Corrigendum
for
Flat panel C-arm with DSA for the Department of
Radiology

NIT Issue Date	: 30 th July, 2019
NIT No.	: Admn/Tender/26/2019-AIIMS.JDH
Pre-Bid Meeting	: 12 th August, 2019 at 03:15 PM
Earlier Last Date of Submission	: 14 th November, 2019 at 03:00 PM
Extended Last Date of Submission	: 28 th November, 2019 at 03:00 PM
Bid opening	: 29 th November, 2019 at 03:15 P.M

The following revised and additional specification will be added:-

10. Page No. 13: Point L

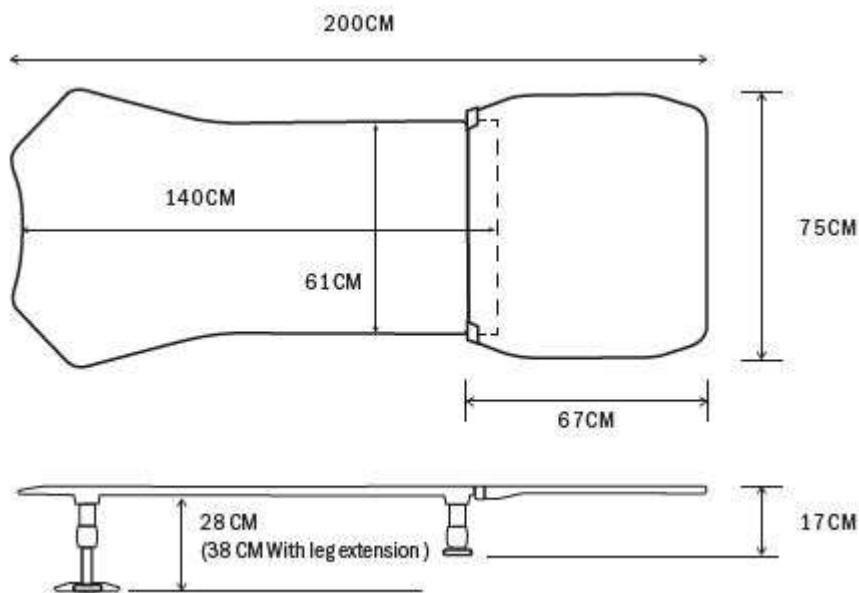
Lead Barrier:

Lead Barrier: (One with following specification)

11. Page No. 13:

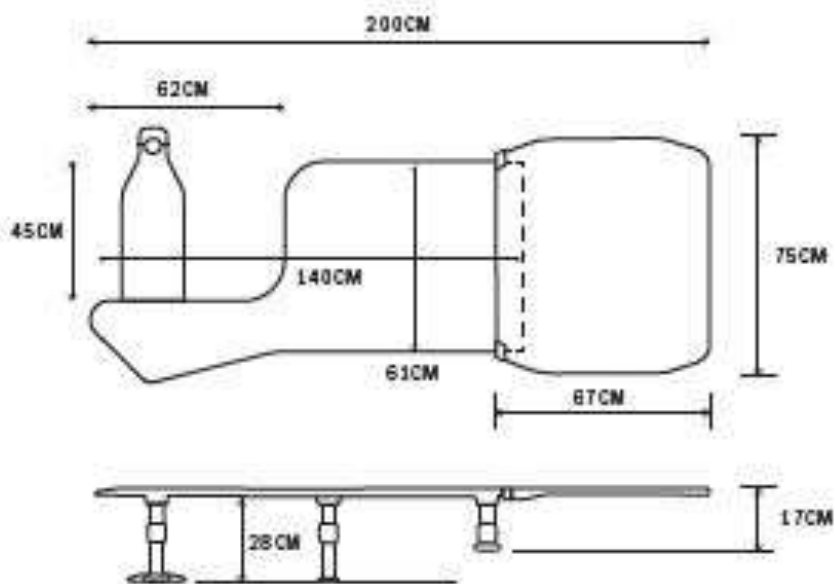
Please Add (New Point) “N”

IR Platform 1 : An over patient flat top work surface to provide work surface for procedures requiring retrograde femoral access (After discussion with the Department).The system should have the following broad specifications:

IR Platform 2 with drape support: An over patient flat top work surface to provide work surface for procedures requiring antegrade femoral access (After discussion with the Department). The system should have the following broad specifications:

- Strong work surface
- Radiolucent material
- Option for extension
- Easy to clean
